AGENDA
SPECIAL MEETING OF THE BIRMINGHAM PLANNING BOARD
THURSDAY DECEMBER 16, 2021
151 MARTIN ST., CITY COMMISSION ROOM 205, BIRMINGHAM MI *
*******7:30 pm*******

SUBJECT: 211 Hamilton Row - Sybil – Special Land Use Permit, Final Site Plan & Design Review

SUBJECT: 460 N. Old Woodward – Final Site Plan and Design Review

NORTH
FLOOR PLAN
SCALE: 1/4"=1'-0"

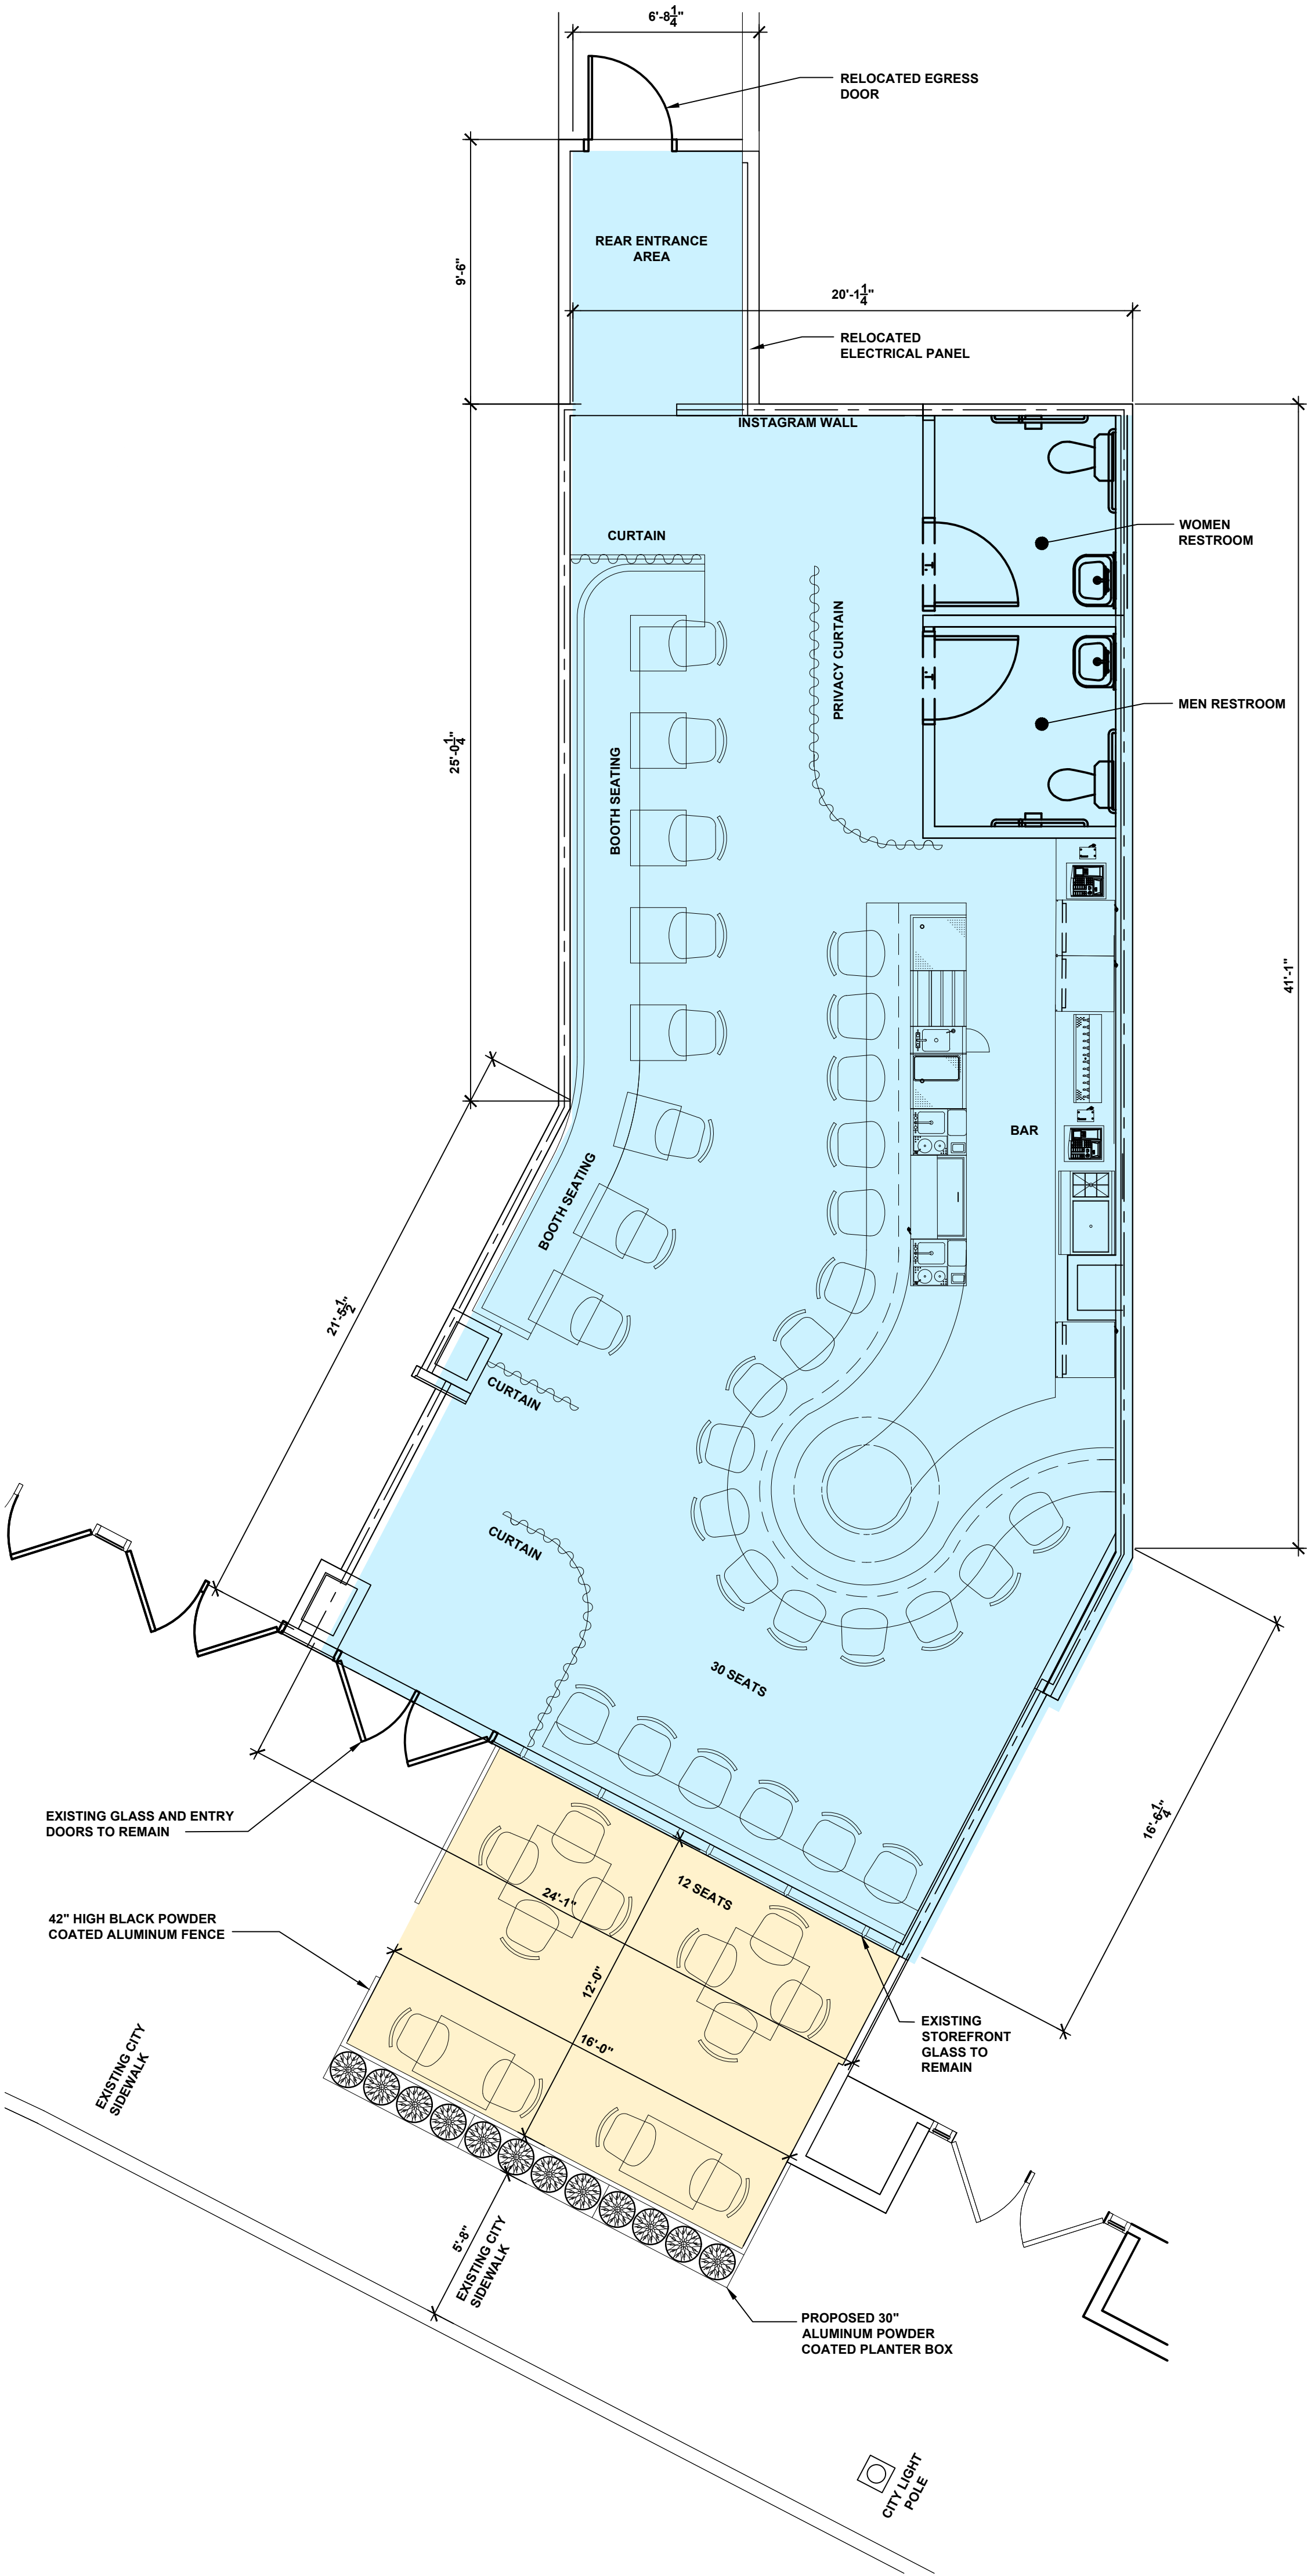
The applicant has also provided a dimension indicating that a 5 ft. 8 in. clear path will be maintained from the curb along Hamilton Row to the front of the planter boxes. This area is comprised of predominantly exposed aggregate, and will force pedestrians to take an awkward route around the outdoor dining patio. The Planning Division recommends that the Planning Board discuss the potential to reduce the size of the patio and redesign/relocate the planters to a different area to reduce the impact of the dining patio on pedestrian traffic.

Before the Engineering Department can approve the use of the exposed aggregate concrete as the primary walkway, the designer would need to evaluate the planned walking path for ADA compliance. If this area is not to ADA compliance the walking path cannot be diverted into this space. Alternatively design considerations should include keeping a clear 5 foot wide walkway in the existing regular concrete walkway, either eliminating the high-top tables or moving them into the exposed aggregate area.

A.201

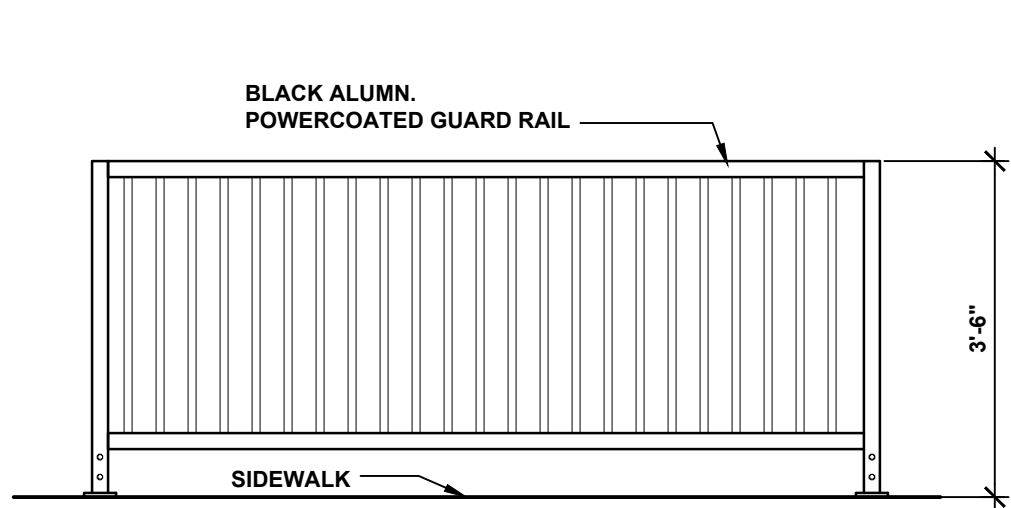
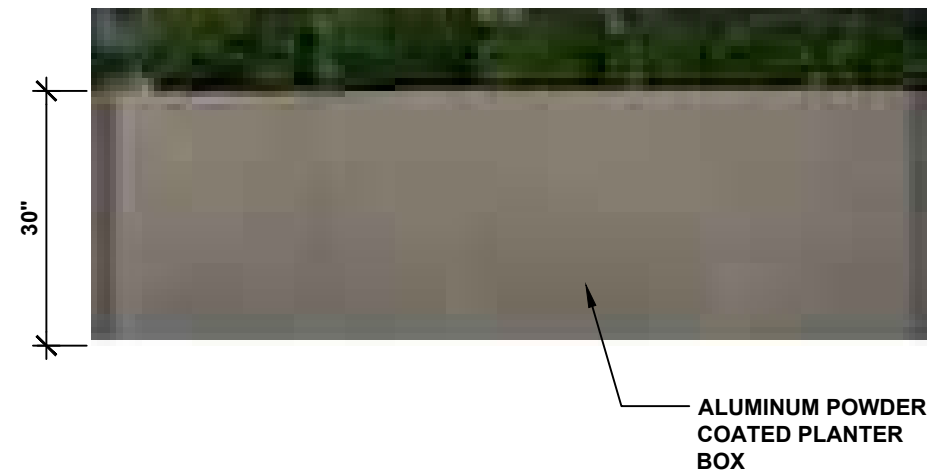
To define the space, the applicant is proposing a 42 in. black aluminum railing around all sides with a small opening on the west side, and an aluminum powder coated planter box along Hamilton Row. The specifications for the tables and chairs have not been provided. **The applicant must submit specification sheets for the proposed tables and chairs to ensure compliance with Article 4, Section 4.44 of the Zoning Ordinance.**

1. The applicant must submit specification sheets for the proposed tables and chairs to ensure compliance with Article 4, Section 4.44 of the Zoning Ordinance;
2. The applicant must submit sign plans for review by the Planning Board prior to the public hearing at the City Commission; and
3. The applicant must comply with the requests of all City Departments.
